## City of Ketchum

### **Recommendation to Hold a Public Hearing and Approve the Lofts at 660 1<sup>st</sup> Avenue Condominium Preliminary Plat**

**Attachment B.**  
**Preliminary Plat dated August 2020**

IN RE: )  
)  
Lofts at 660 1<sup>st</sup> Avenue Condominium Subdivision ) KETCHUM CITY COUNCIL  
Preliminary Plat ) FINDINGS OF FACT, CONCLUSIONS OF LAW, AND  
Date: September 21, 2020 ) DECISION  
)  
File Number: P20-052 )

SHEET 1 OF 3  
 Job No. 7724

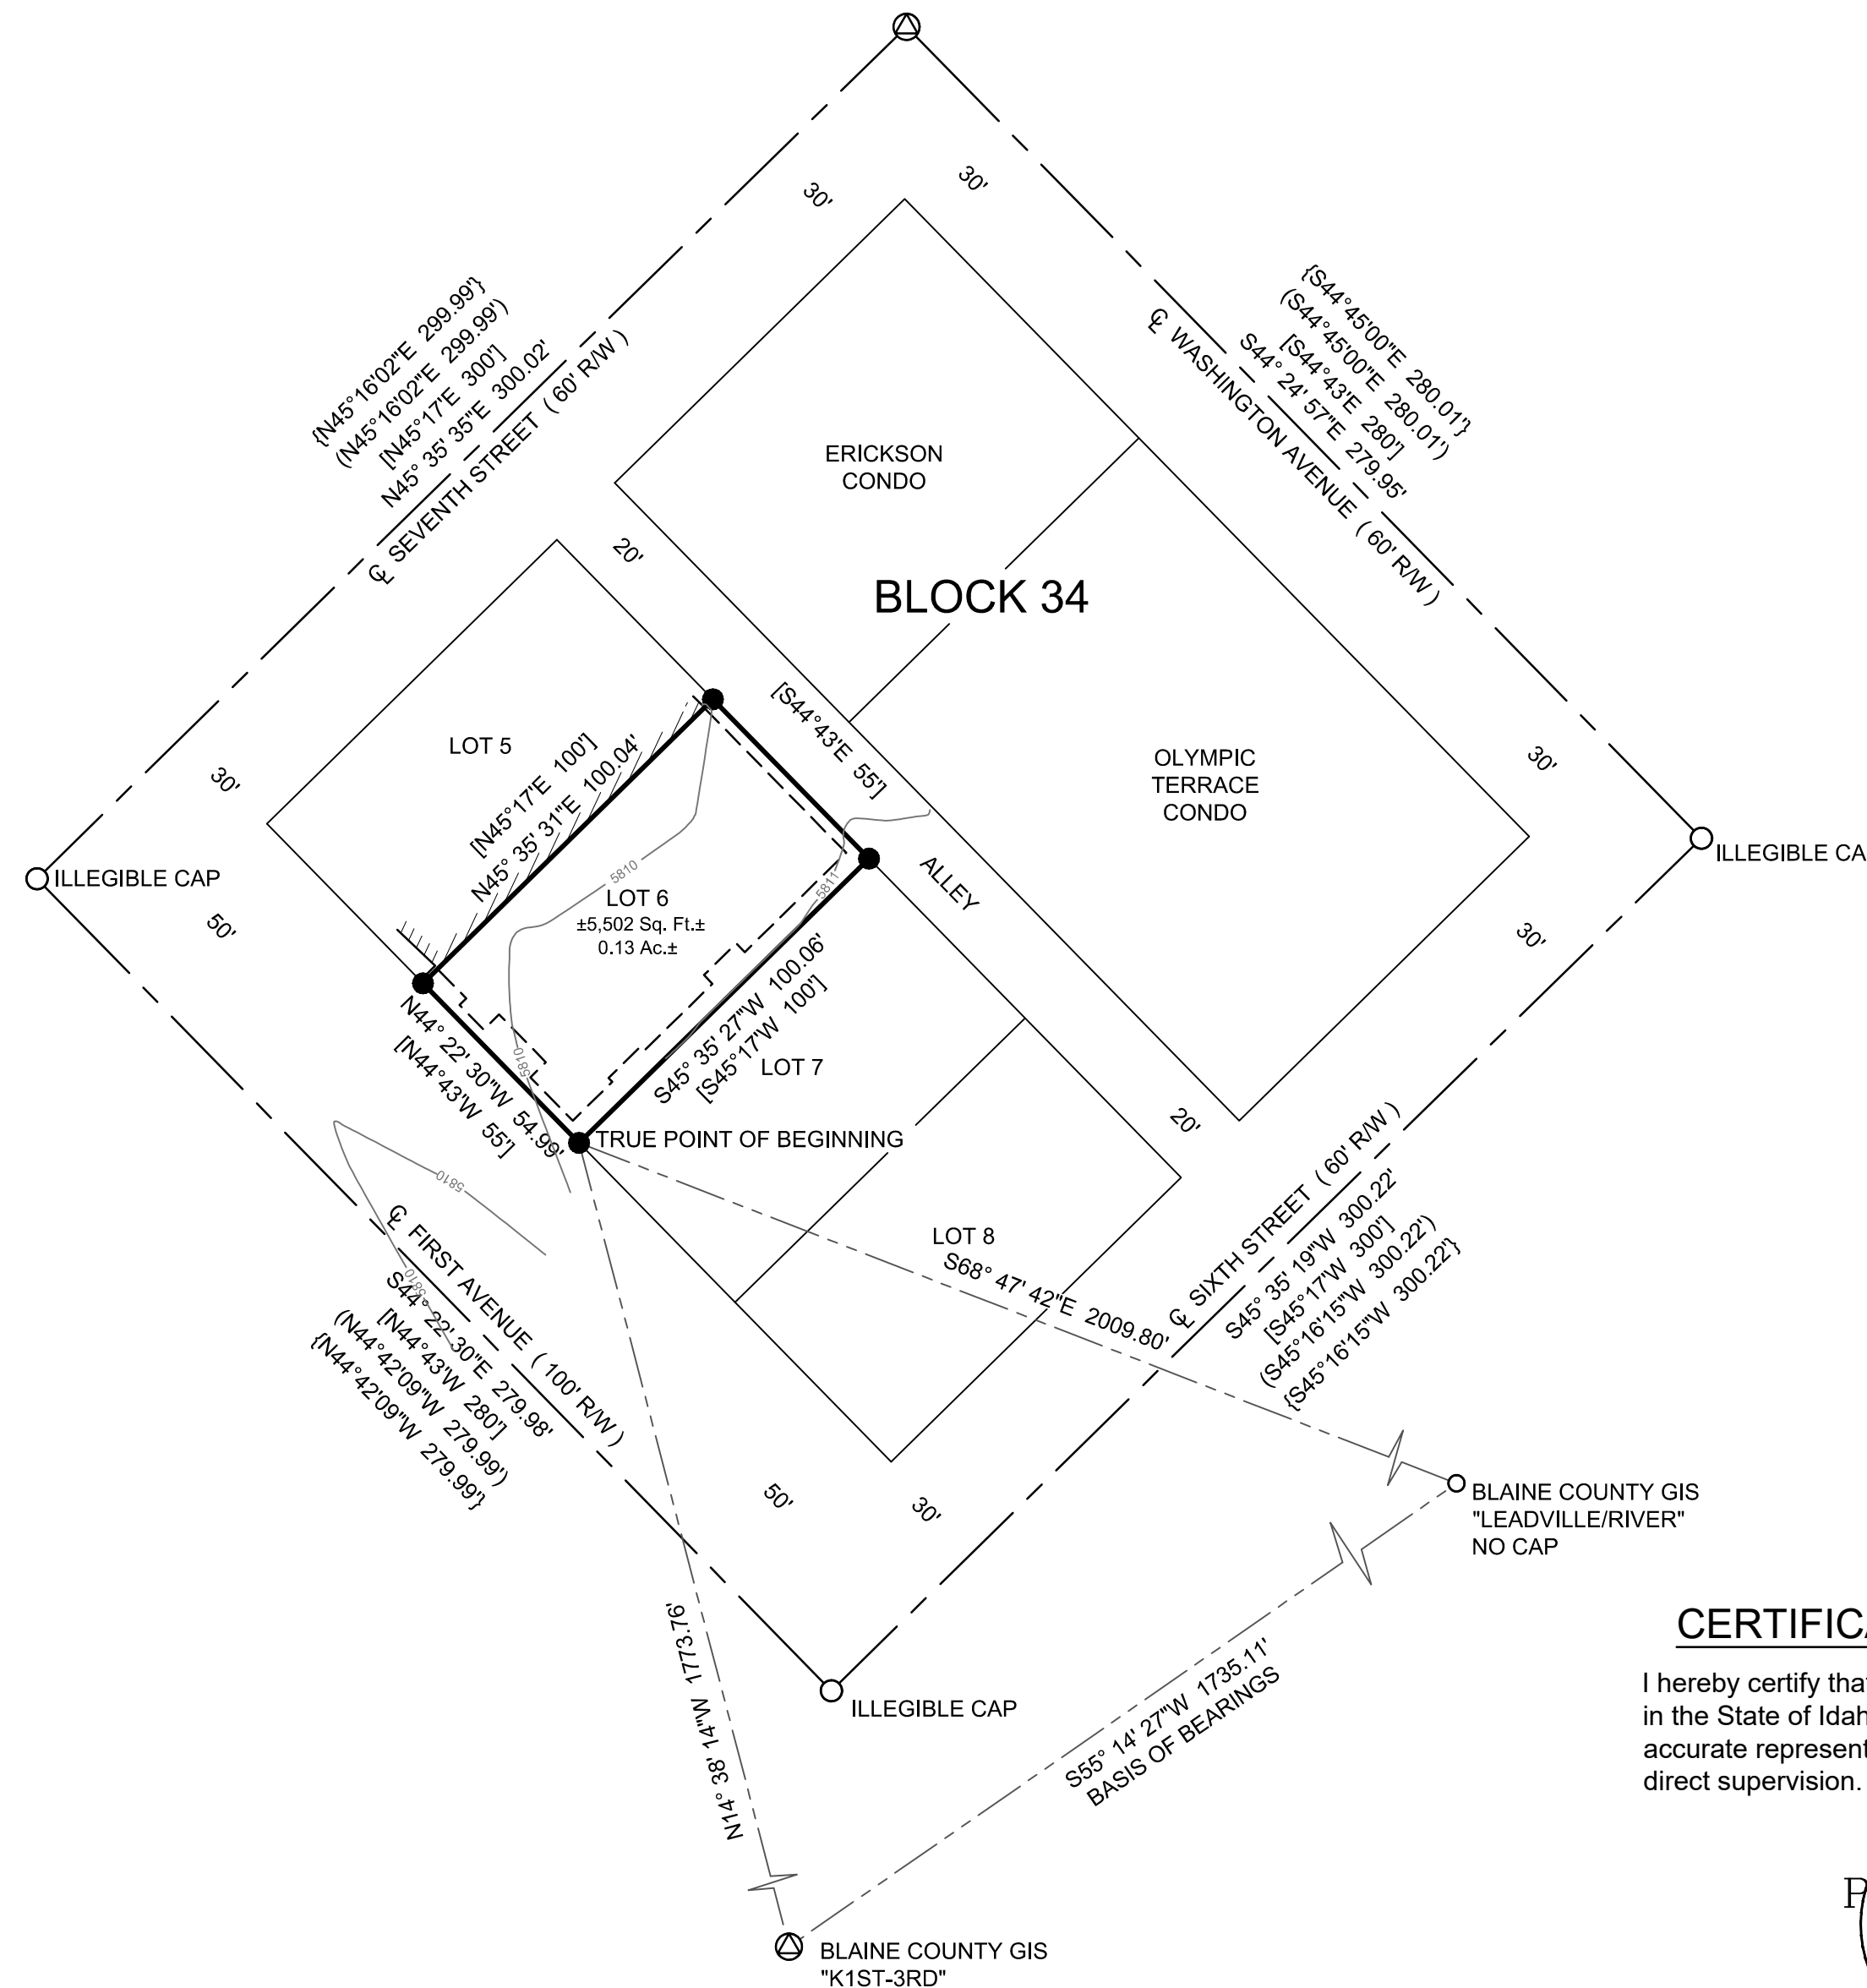
<input type="checkbox"/>	X	<input type="checkbox"/>	<b>16.04.030. J.6</b>	<b>A contour map of the subdivision with contour lines and a maximum interval of two feet (2') to show the configuration of the land based upon the United States geodetic survey data, or other data approved by the city engineer.</b>
			<b>Comments</b>	Present
X	<input type="checkbox"/>	<input type="checkbox"/>	<b>16.04.030. J.7</b>	<b>The scaled location of existing buildings, water bodies and courses and location of the adjoining or immediately adjacent dedicated streets, roadways and easements, public and private.</b>
			<b>Comments</b>	Present
X	<input type="checkbox"/>	<input type="checkbox"/>	<b>16.04.030.J .8</b>	<b>Boundary description and the area of the tract.</b>
			<b>Comments</b>	Present
X	<input type="checkbox"/>	<input type="checkbox"/>	<b>16.04.030.J.9</b>	<b>Existing zoning of the tract.</b>
			<b>Comments</b>	Present. See plat note #8.

<b>Comments</b>	Alley improvements were addressed with Design Review and Building Permit approvals.
X	<input type="checkbox"/>	<input type="checkbox"/>	<b>16.04.040.J.1</b>	<b>J. Required Easements: Easements, as set forth in this subsection, shall be required for location of utilities and other public services, to provide adequate pedestrian circulation and access to public waterways and lands. 1. A public utility easement at least ten feet (10') in width shall be required within the street right-of-way boundaries of all private streets. A public utility easement at least five feet (5') in width shall be required within property boundaries adjacent to Warm Springs Road and within any other property boundary as determined by the City Engineer to be necessary for the provision of adequate public utilities.</b>
			<b>Comments</b>	Plat note #8 states, "Utility easements necessary to allow for access and maintenance of utilities serving."

A PLAT SHOWING THE LOFTS @  
660 1ST AVENUE  
GALENA ENGINEERING, INC.  
HAILEY, IDAHO  
SHEET 2 OF 3  
Job No. 7724

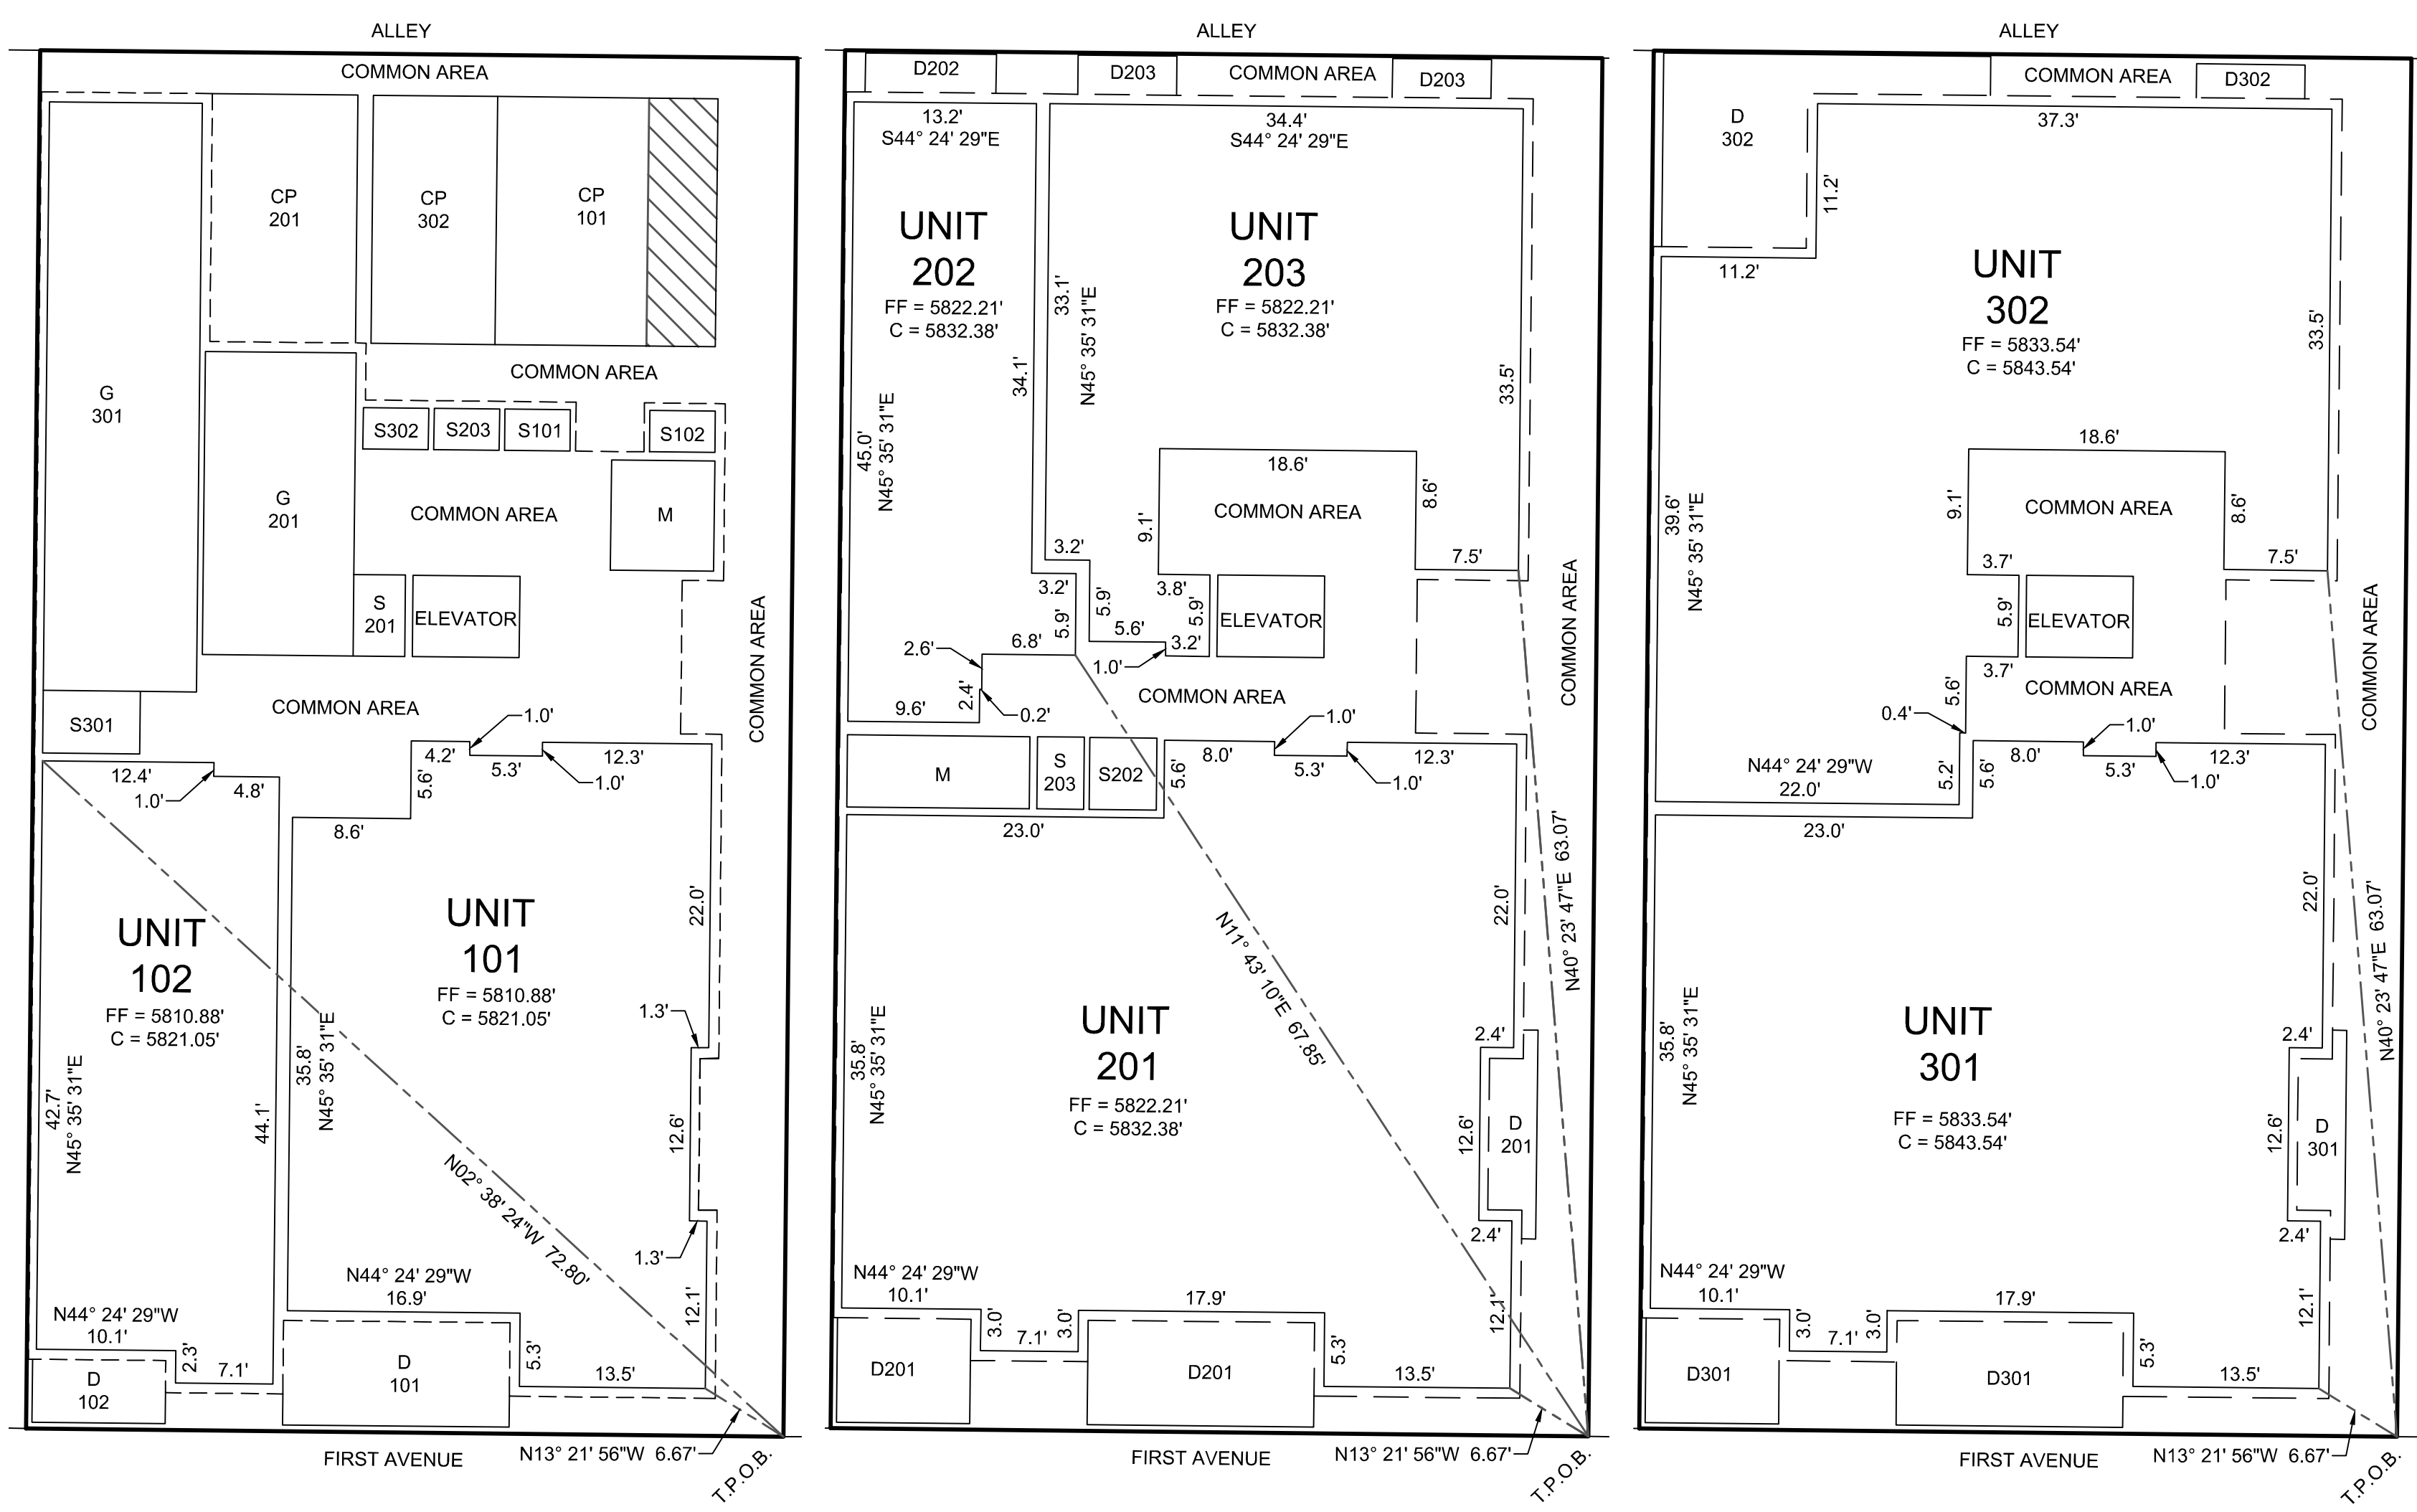
A maintenance room, M, is indicated on the plat.
